PLANNING REPORT

PLANNING AND ZONING COMMISSION

4. National Church Residences at Avondale Woods **5215 Avery Road**
08-100CP **Concept Plan**

Request: Review of a concept plan under the Planned District provisions of Code Section 153.050 for a future rezoning/preliminary development plan application.

PROPOSED SITE PLAN

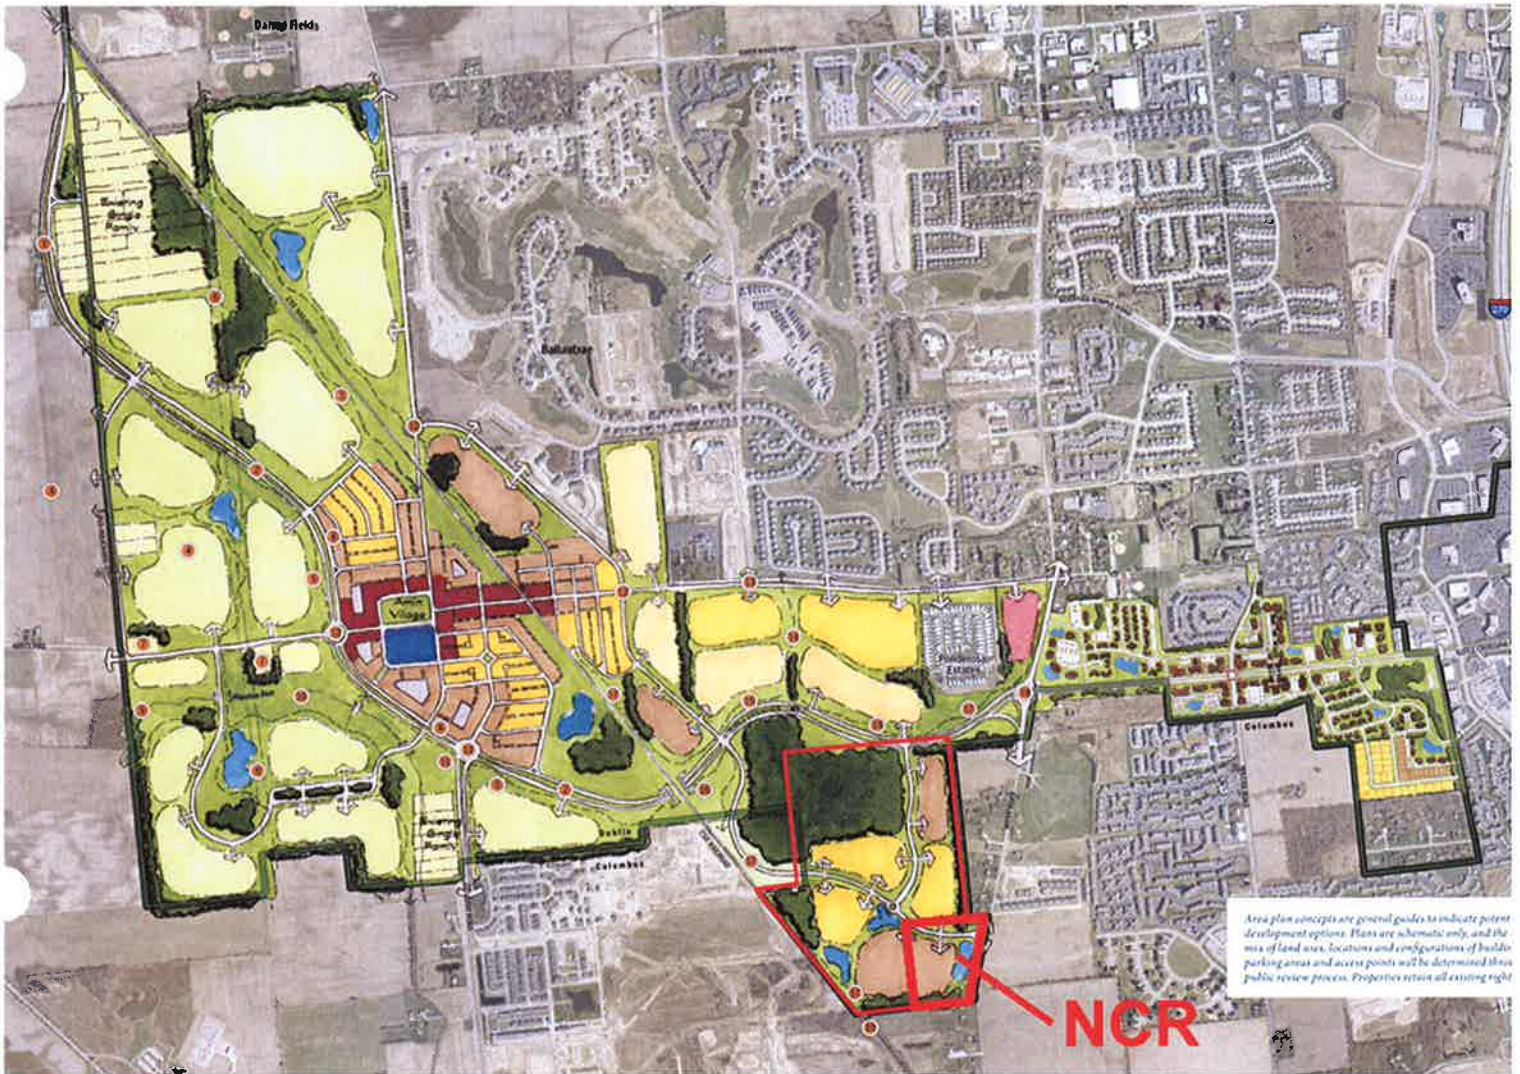
Building setbacks are 30 feet along the northern edge of the site and 100 feet along the eastern edge. Pavement and landscaping currently shown within an existing 40-foot water line easement along the southern property line will need to be removed or an easement encroachment agreement obtained.

No screening or buffering is shown along the southern property line, and the plans indicate that a property screen consisting of landscaping and a fence will be installed on the western boundary of the site. The applicant will be required to provide more details regarding the perimeter screening to determine whether the proposal meets Code requirements for perimeter landscaping, and Planning recommends including a buffer consisting of mounding or plant material along the

southern property line to screen the future Britton-Cosgray Connector and to minimize potential impacts of this planned roadway.

- Provide more of a streetscape appearance within the development to create an attractive public realm.
- The frontage of the site along Avery Road should implement Dublin Model Character landscape treatment to coordinate with future development along this corridor.
- Construct mounds between any stormwater retention ponds along the eastern portion of the site and the Avery Road right-of-way to avoid becoming safety hazards.

- Provide a pedestrian connection to the west so that future development may have access to the proposed community center and to Avery Road.

- Provide additional details regarding the screening and plantings shown along the western edge of the development.
- Provide a buffer along the southern property line with mounding and plant material to screen the future Britton-Cosgray Connector to the south.

PROPOSED ELEVATIONS OPTION 1

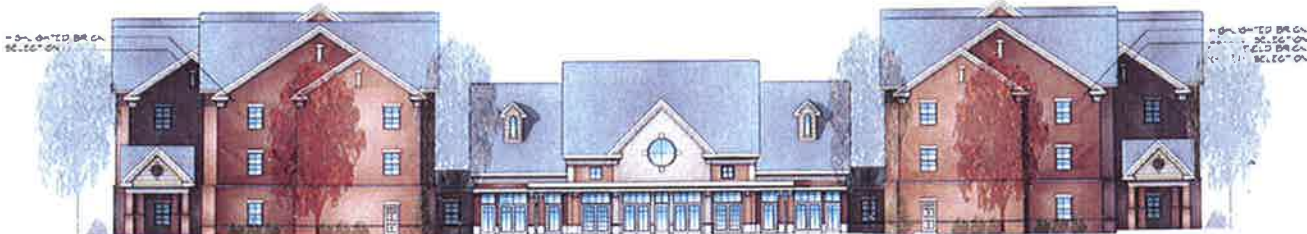
Planning recommends that a version of the first option be used, with some modifications. The first option utilizes a greater percentage of stone on the elevations, which will assist with

breaking up the building façades. Planning also recommends incorporating a greater use of material changes to create more of a vertical, townhome appearance. This will provide architectural interest and further reduce the visual impact of the building.

- *Given the nature of the proposal, does the Commission support the proposed architectural concepts?*
Planning has recommended that the three-story building utilize different materials in order to create the appearance of individual “townhome” units to break up the long building façades and contribute to the architectural interest of the building for this gateway into the city’s southern region.

- The architectural concept for the three-story buildings in particular should be distinctive in character and oriented toward Avery Road.
- The three-story building design should bear more of a resemblance to town homes or “row houses” to further reduce the perceived mass of the building elevations and to provide architectural interest.
- Break up the single-story buildings with five, six, or seven dwelling units into smaller groups of three to four dwelling units in order to decrease the mass of these buildings.

PROPOSED ELEVATIONS OPTION 2

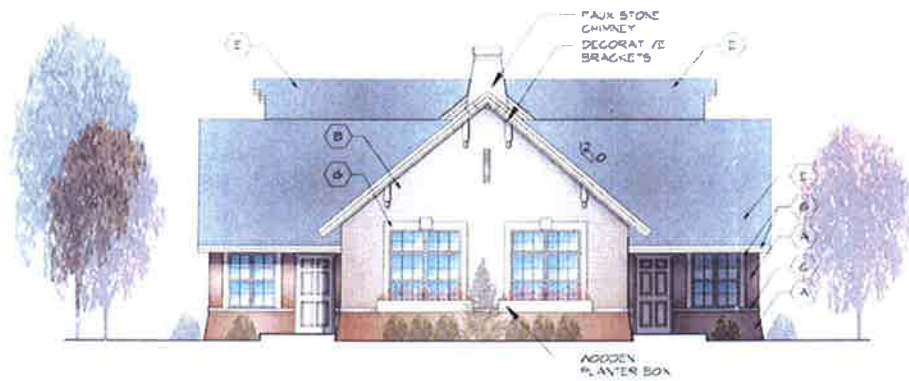
The applicant has requested that two architectural concepts for the proposed three-story independent living buildings be submitted to the Planning and Zoning Commission, both of which are included in the packet. Both options primarily use brick and stone veneer with cementitious siding for accents. The first option depicts the buildings as primarily composed of brick with stone applied to portions of the north and south elevations and also on the east and west ends of the three-story buildings and on the community center building. The second option is very similar to the first in that although the structure has not changed, a lower percentage of stone has been utilized on the building elevations.

PROPOSED ELEVATIONS ONE-STORY COTTAGES

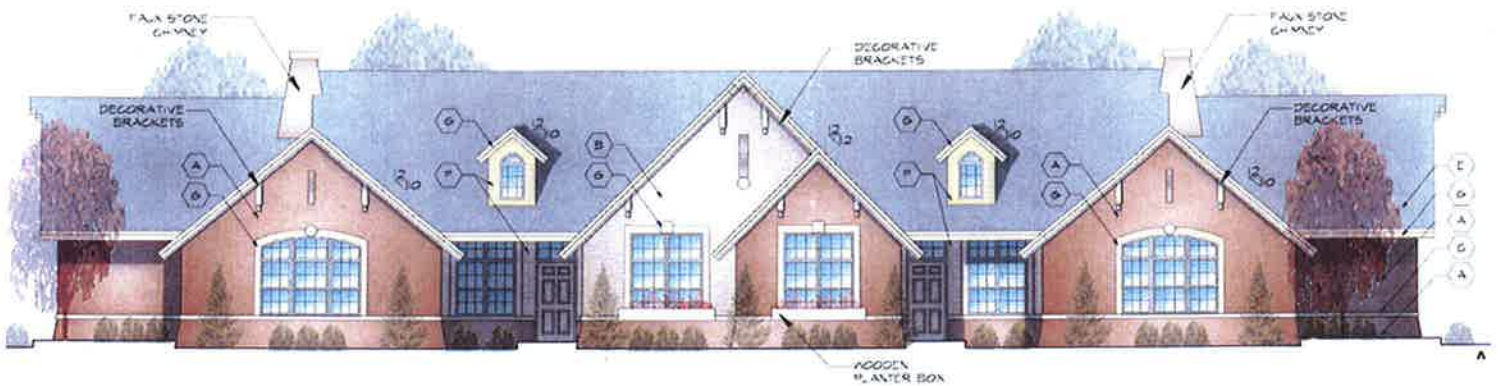
The cottage units are primarily located along the perimeter of the site and help provide a transition to the anticipated single family development to the west. Primary building materials are brick and stone veneer with cementitious siding and aluminum trim as accents to coordinate with the three-story buildings. The applicant has indicated that the individual units will be architecturally treated to assist residents with wayfinding and identifying the units. Planning recommends that the buildings with five, six, or seven dwelling units be broken up into smaller groups of three to four dwelling units in order to decrease their mass.
